In the Drawings:

REMARKS

Appl. No. 10/696,102
Response to 04/11/2006 Office Action
Atty. Dkt. MI40-363

~~3/8~~
3/9

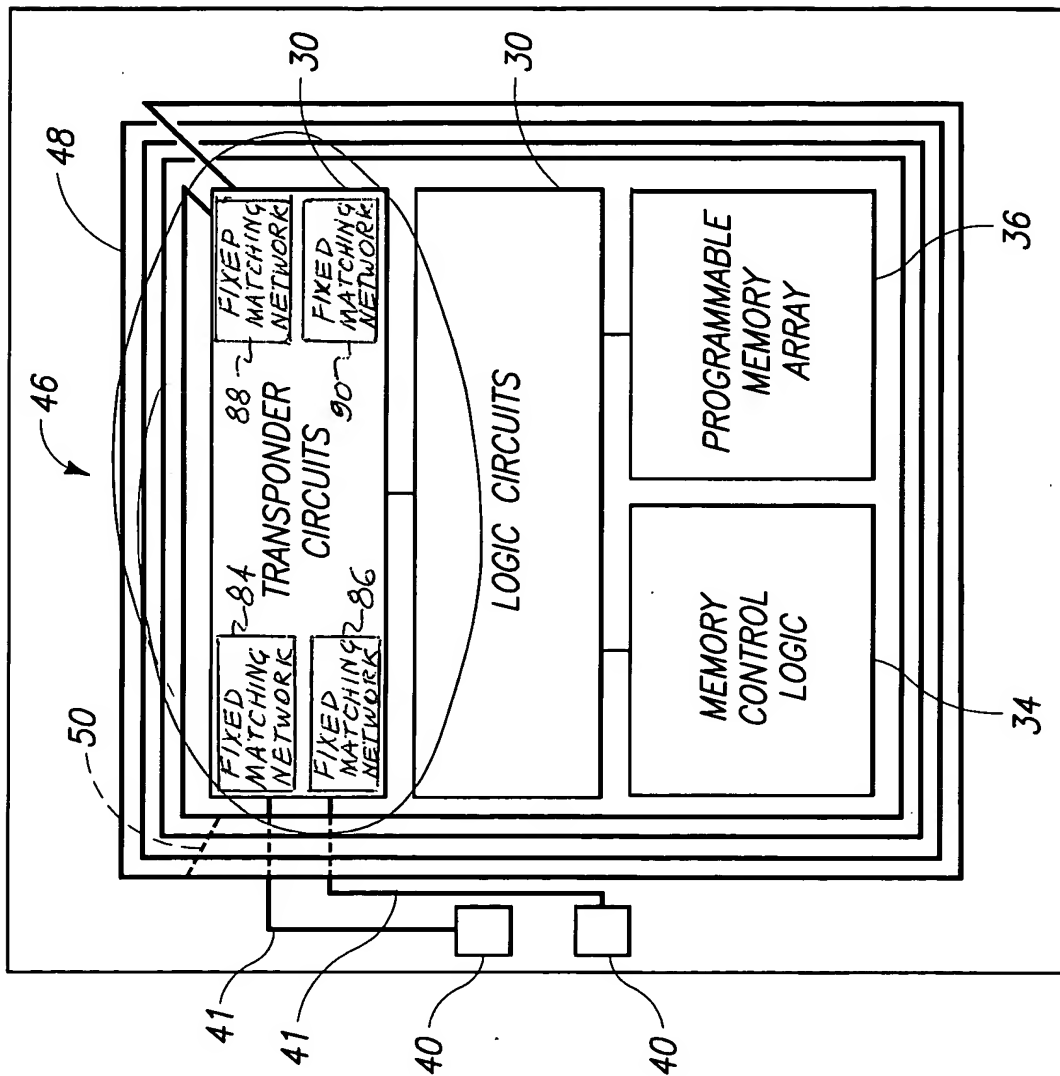
New Sheet 3/9, which includes Fig. 5, replaces the original sheet including Fig. 5. In Fig. 5, matching networks 84, 86, 88 and 90 have been added.

9/9

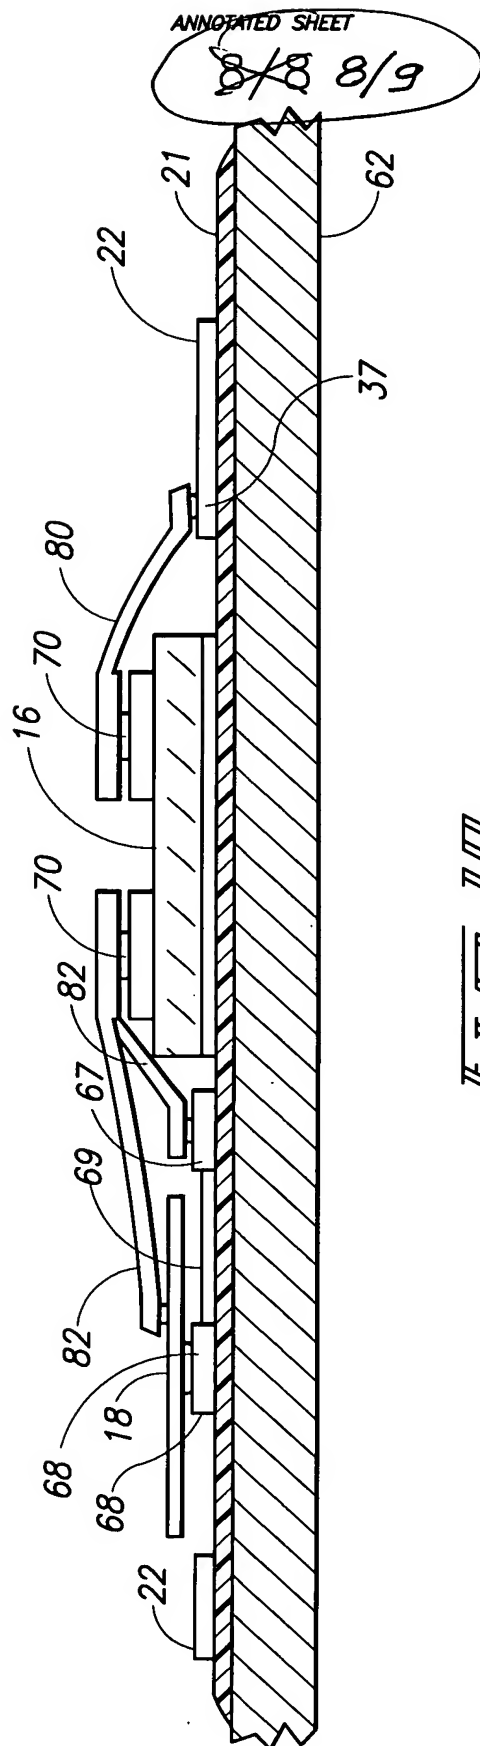
New Sheet 9/9 includes new Figs. 11 and 12.
